Product Change Notice (PCN)

PCN Number: **PCN-0451148R-01**

Product(s) Affected: PJ-037A

Description of Change: mechanical differences as shown below:

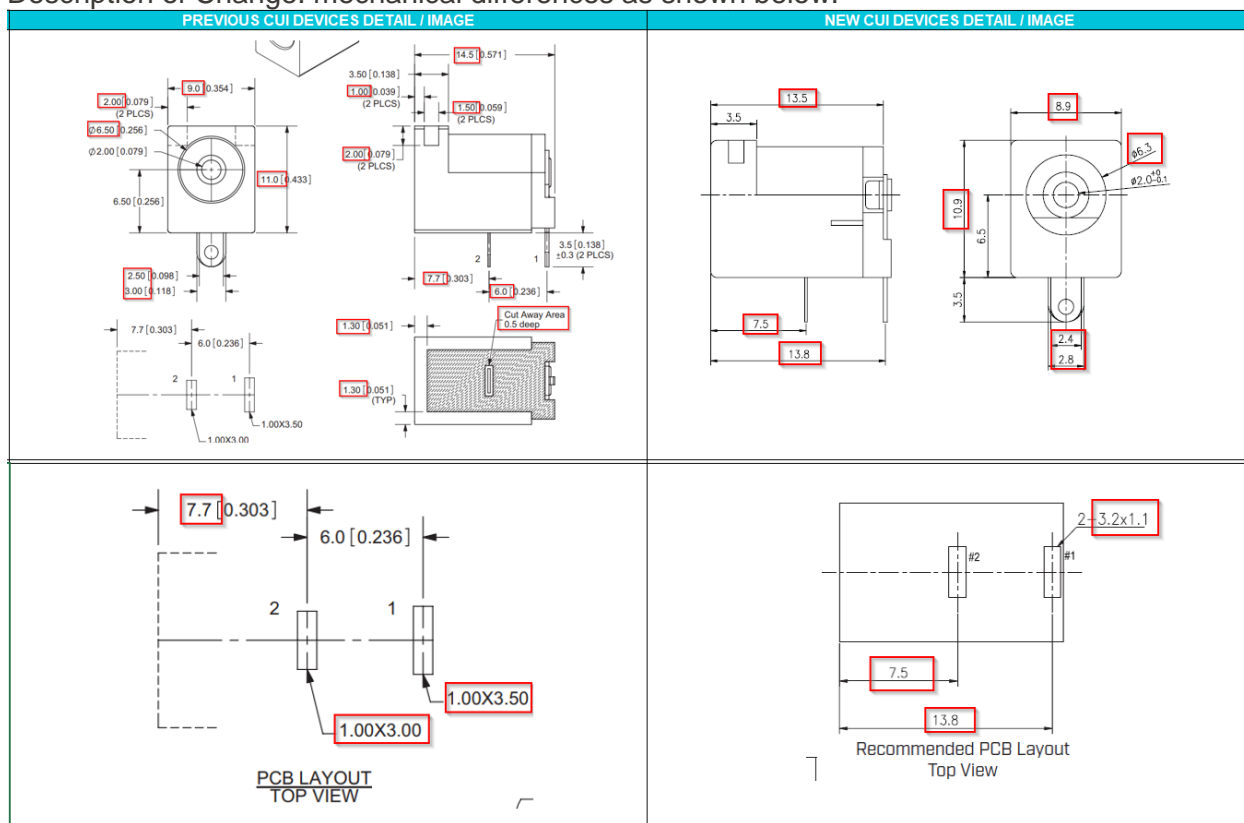
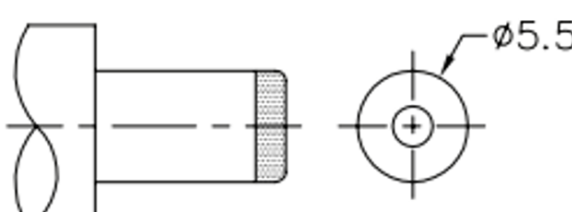
MATERIAL	PLATING
center pin	copper	nickel
terminal 1	brass	tin
terminal 2	copper alloy	tin
plastic	PBT

DESCRIPTION	MATERIAL	PLATING/COLOR
center pin	copper alloy	nickel
terminal 1	brass t=0.3 mm	nickel-silver
terminal 2	phosphor bronze t=0.3 mm	nickel-silver
housing	PBT (UL94V-0)	black
cover	PBT (UL94V-0)	black

MATING PLUG
Jack Insertion Depth: **9.0 mm**

MATING PLUG
Jack Insertion Depth: **9.8 mm**

Insertion/extraction force adjusted to 0.3 ~ 2.0 kg
